Subject: **Modification Request for Nationwide Permit 14, Section 401 Water Quality Certification and Revised Application for a CAMA Major Development Permit** for the Proposed Replacement of Bridge No. 38 over Trent Creek on NC 55 in Pamlico County, North Carolina; TIP No. B-4593; Debit \$570 from WBS No. 42328.1.2

LOCATION: BRIDGE NO. 38 ON NC 55 OVER TRENT CREEK
TYPE OF WORK: GRADING, DRAINAGE, PAVING AND STRUCTURE.

PERMIT DRAWINGS
STREAM AND WETLAND IMPACTS

09-JUL-2019 14:19
B35538_H03_110ash_OH.pfl.dgn
jason@starkoski.com

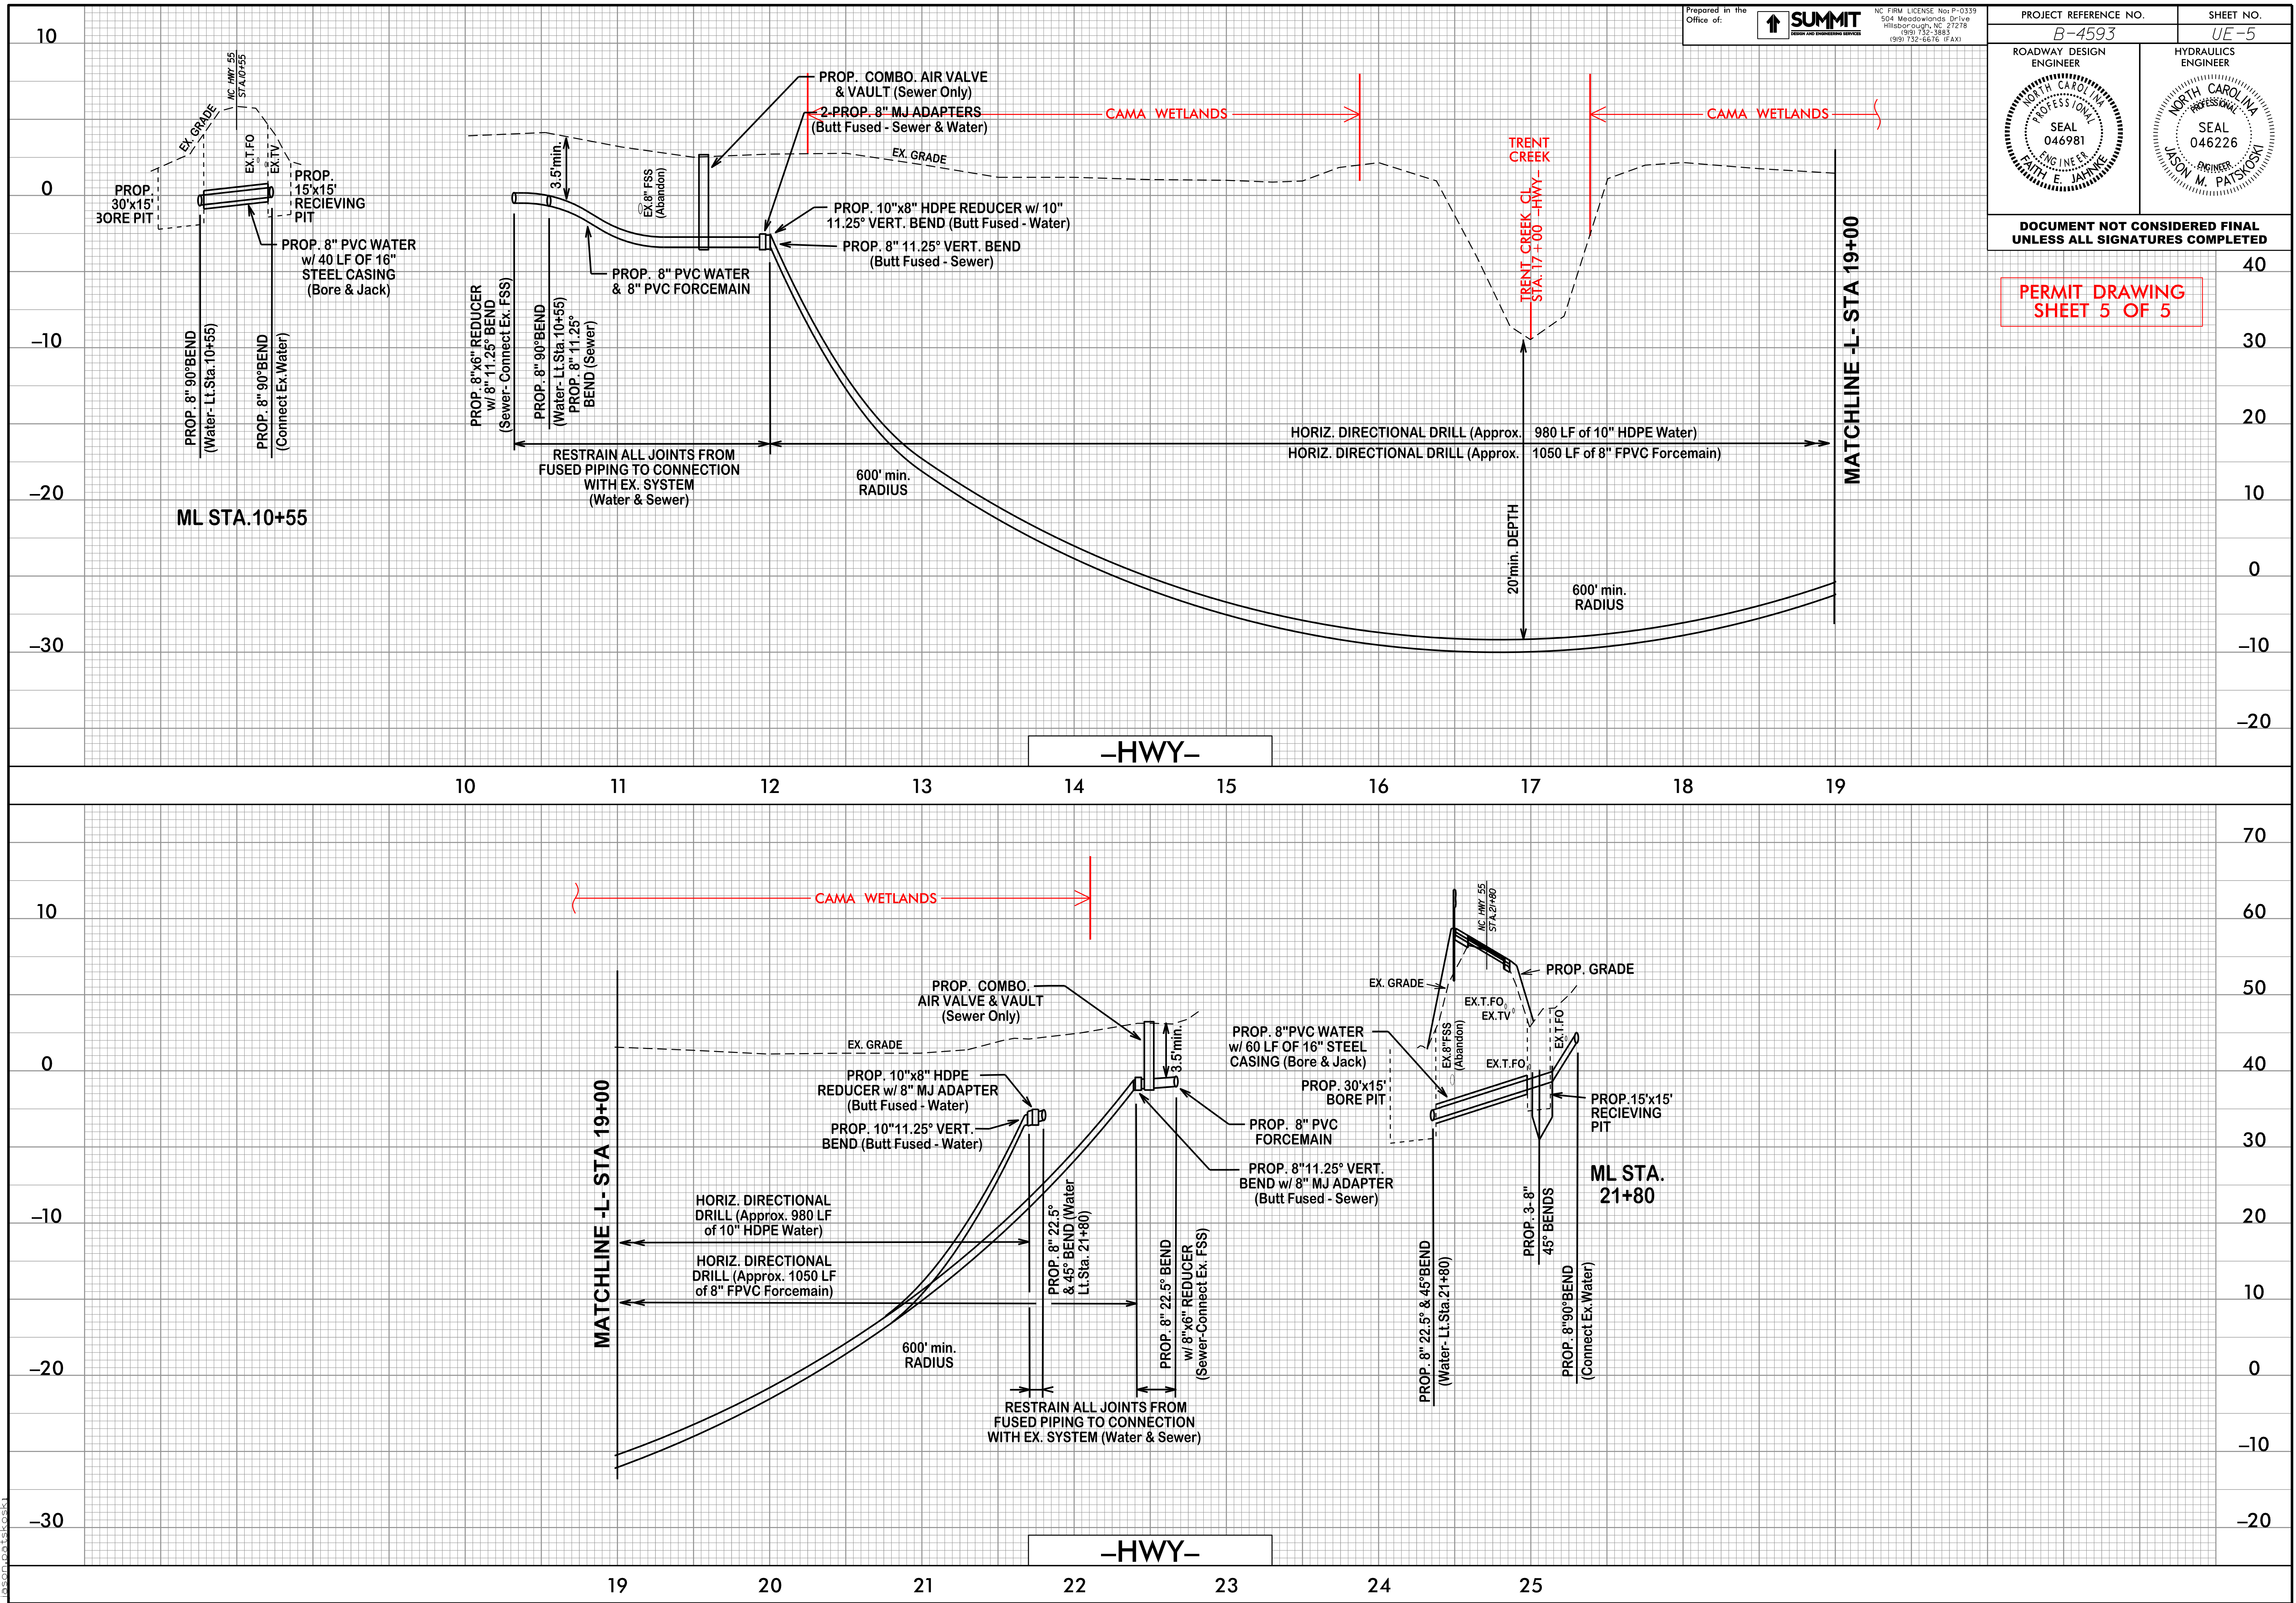
- Excavation/Hand Clearing limits revised for northwest waterline bore pit
- Excavation/Hand Clearing limits revised for northeast waterline bore pit
- Excavation/Hand Clearing limits revised for sanitary sewer open cut
- Excavation added for the southeast waterline receive pit which is within the wetland boundary
- Excavation Summary on UE-3 revised

TOTAL EXCAVATION
(THIS SHEET):
0.01 ACRES SITE 3
